Wollongong Local Planning Panel Assessment Report | 13 August 2020

WLPP No.	Item 3
DA No.	DA-2019/998
Proposal	Residential – demolition of structures on Lots 1 and A, site remediation works, realignment of stormwater pipe, Subdivision of three (3) existing lots to create four (4) Torrens title lots, construction of single dwelling on one (1) lot and dual occupancies on two (2) of the new lots and Subdivision - Torrens title of each dual occupancy into two (2) lots
Property	34-36 Hewitts Avenue Thirroul
Applicant	Hewitts Land Pty Ltd
Responsible Team	Development Assessment and Certification - City Wide Team (NA)

ADDENDUM REPORT

Figure 1: Extract from DP 1225874 showing encroachment and easement

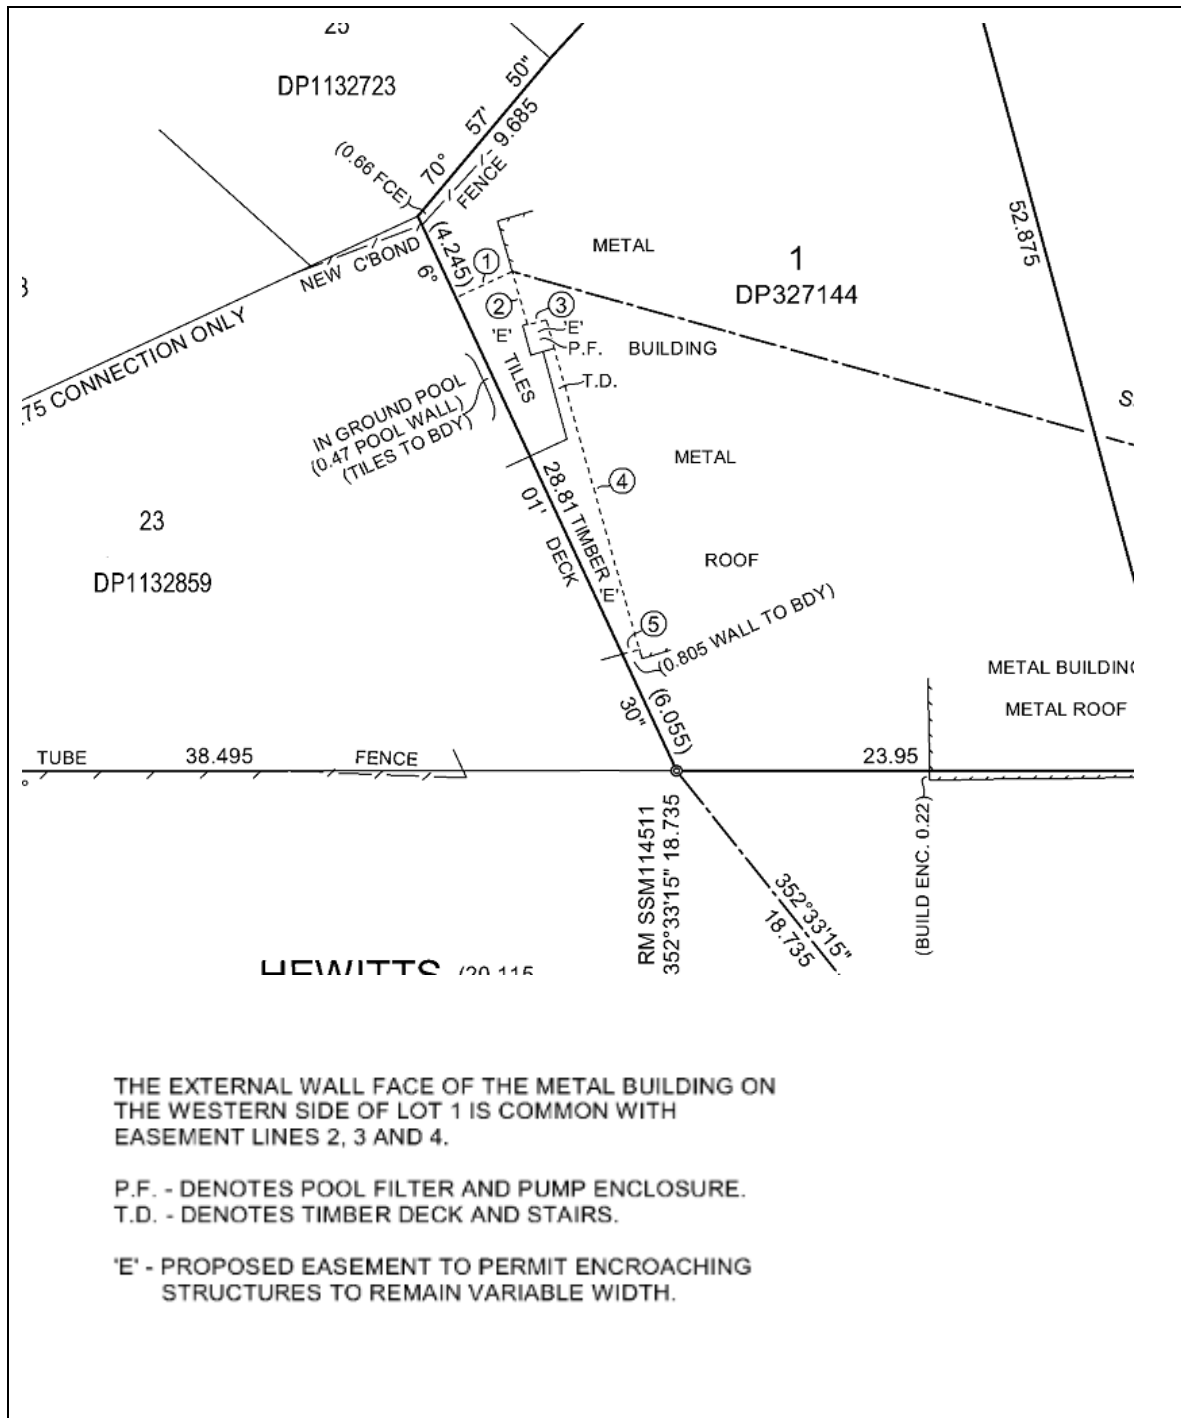
b) Details of the form and type of encroachment adjacent unit No. 38b along the western boundary.

Comment: The encroachment arising over the western end of the site is an encroachment by the swimming pool area (tiles and pump enclosure) and timber deck and stairs, as shown below on the extract from DP 1225874.

WEST ELEVATION
UNIT 38

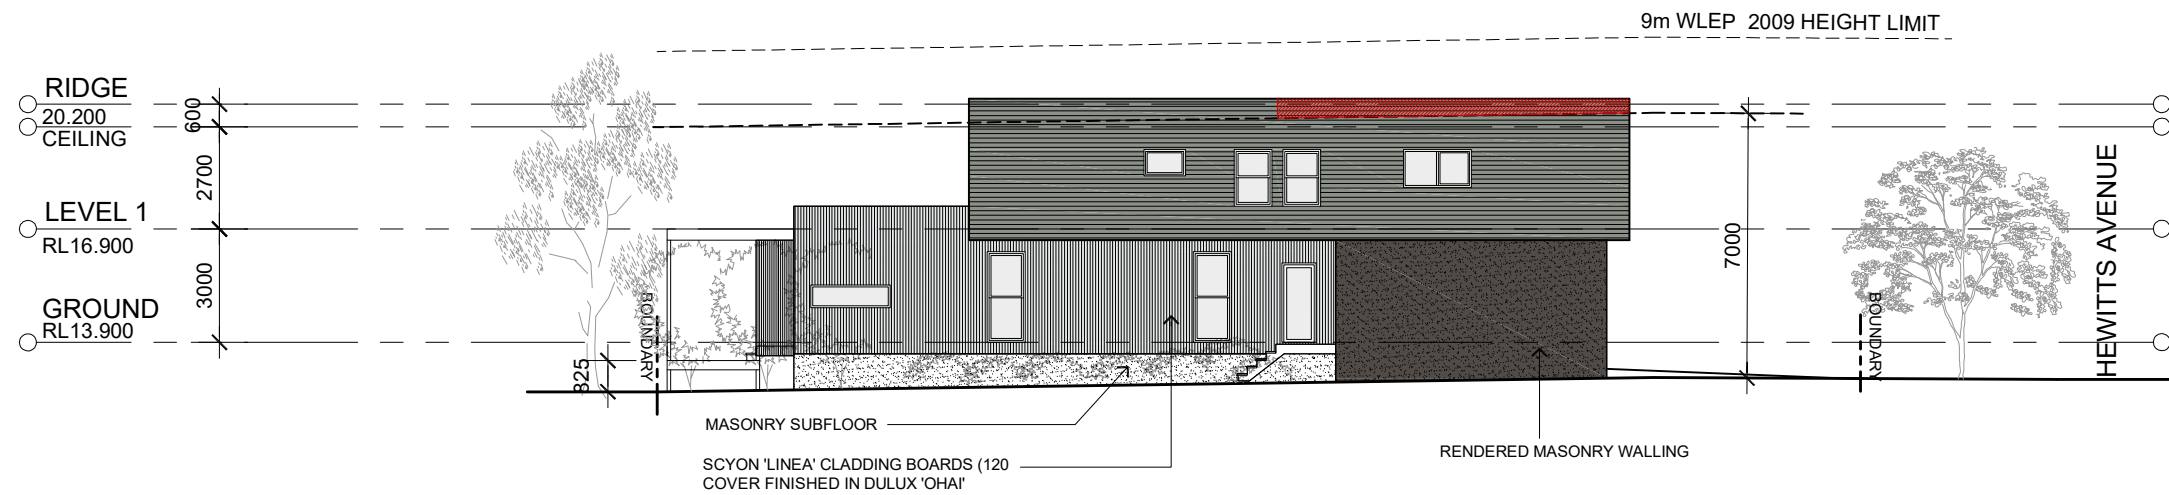
The amended plans also propose a variation to the height of the western wall of the dwelling on proposed Lot 38, with a wall height of approximately 7.38 metres within 3 metres of the allotment boundary. The variation occurs over a 7metre length of wall.

4. Privacy impacts on adjoining pool area	<p>The lounge room windows in the western wall of the dwelling on proposed Lot 38 are generally tall narrow windows in locations that do not facilitate overlooking. The kitchen window is located to the north of the adjoining pool area, overlooking a proposed landscaped area on the subject site.</p> <p>The landscape plan indicates a row of planting along the western boundary- this has been conditioned to be suitable screen planting.</p> <p>Windows in the upper storey are associated with bedrooms and bathrooms which are considered to be low usage rooms. A condition is proposed to ensure the bathroom windows are opaque which further restricts overlooking.</p>

Comment: The proposed development is likely to establish the pattern of building separation along the northern side of Hewitts Avenue and will therefore not disrupt an established pattern. There are not expected to be any adverse impacts arising from the minor increased height and as such, the requested variation to side boundary setback is capable of support.

Figure 5 indicates area of proposed dual occupancy block that does not achieve a minimum 15m width

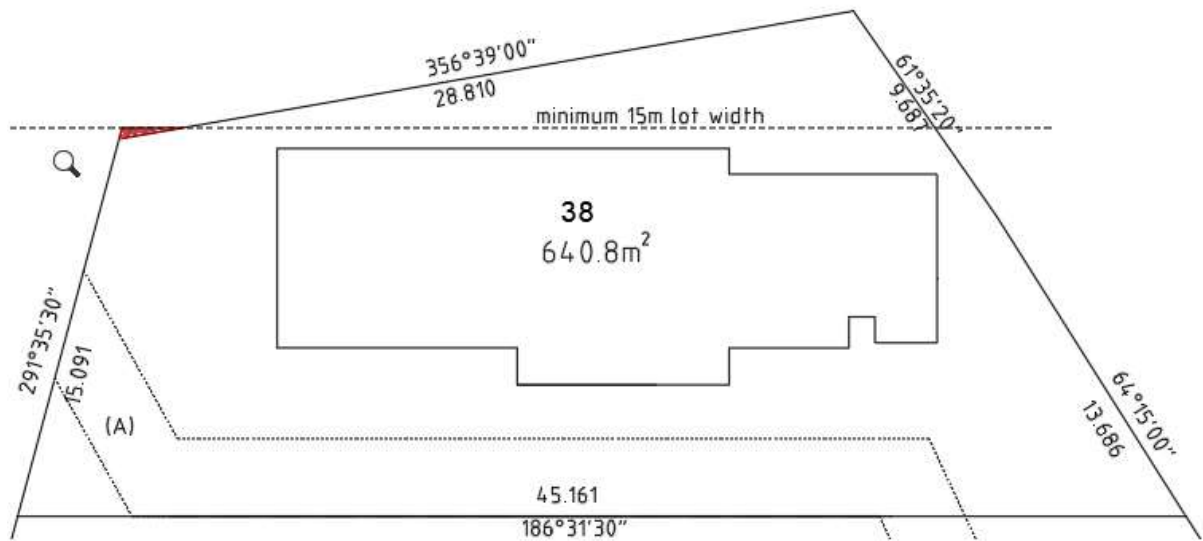
Figure 5 details the minor variation sought to the minimum 15m lot width for dual occupancy developments. The proposed site has an irregular side boundary and as such there is a minor encroachment (approx. 0.5sqm) within the required 15m building width for the allotment. This minor variation does not affect the sites ability to accommodate the required building envelope, car parking,
